Memo

To: Elizabeth Carpenter
From: Dean Brodie
CC: Katherine Tracey, Aaron Chandler
Date: 20 September 2017
Re: Proposed Inner West High School – Response to Authority Comments

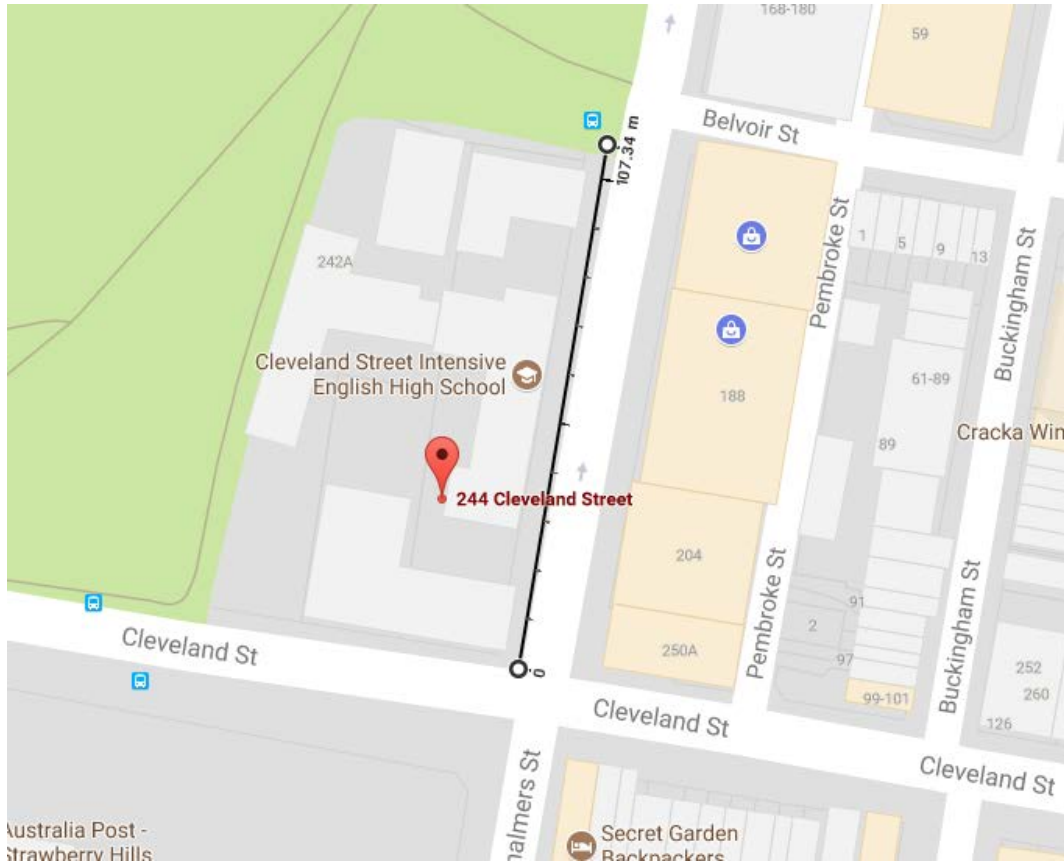
9. ***The proposed use of existing public bus zones/lanes for school buses for special events may have adverse impacts on public bus services. Transport for NSW should be consulted in this regard.***

As discussed and in principle agreed with representatives of TfNSW, the school would provide a No Stopping Zone as per those which have been installed in other areas of the Sydney CBD. These signs are installed below.

The two (2) bus zones would be located adjacent to the existing bus zone / shelter some 100m north of the existing traffic signals.

The location is shown below:

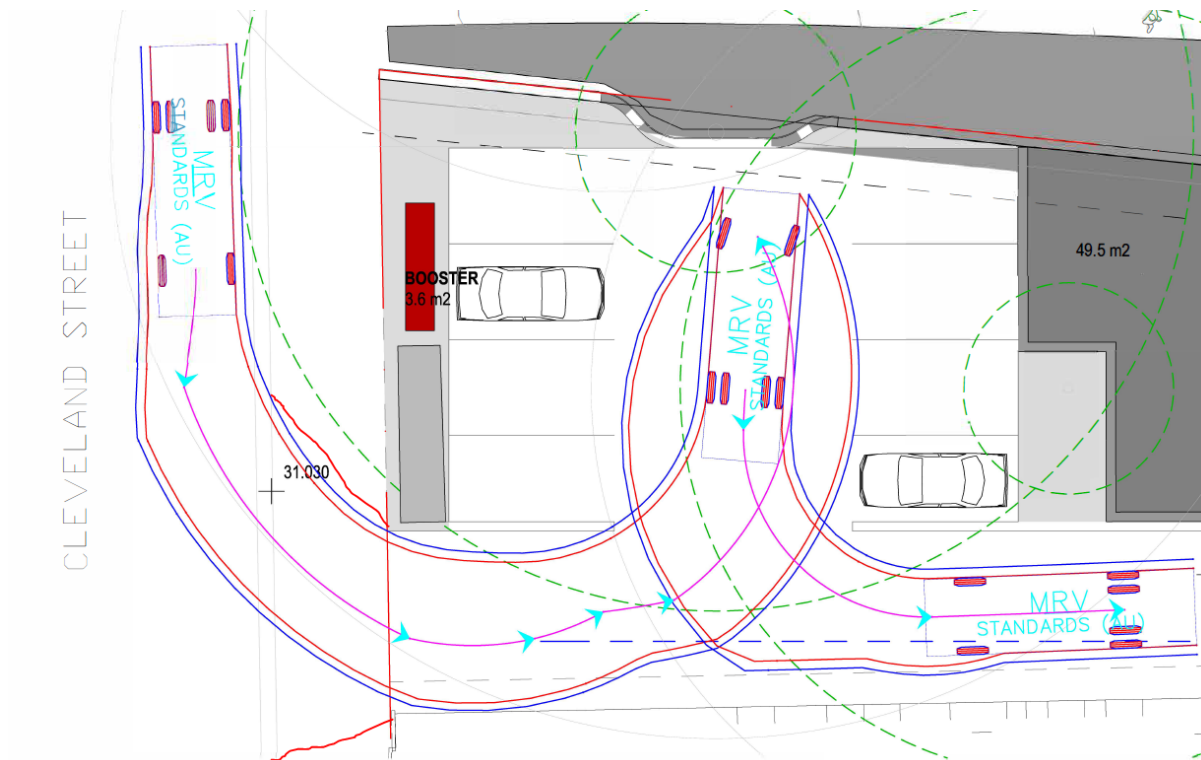
13. ***The swept path of the longest vehicle (including garbage trucks, maintenance and delivery vehicles) entering and exiting the subject site, as well as manoeuvrability through the site to loading areas, is to be in accordance with Austroads requirements.***

The vehicle swept path plan provided does not show detail of the vehicle crossover on Cleveland Street. The swept path plan should be amended to show detail of the crossover and driveway to demonstrate that the largest design vehicle can enter and exit the site in a forward direction, and manoeuvre to loading areas. Should any driveway adjustment works be required, this should be identified in the plans and submitted for Roads and Maritime's review.

The turn path presented in Appendix B of the report needs to include the driveway 'wings' either side of accommodate the turn path as shown below:
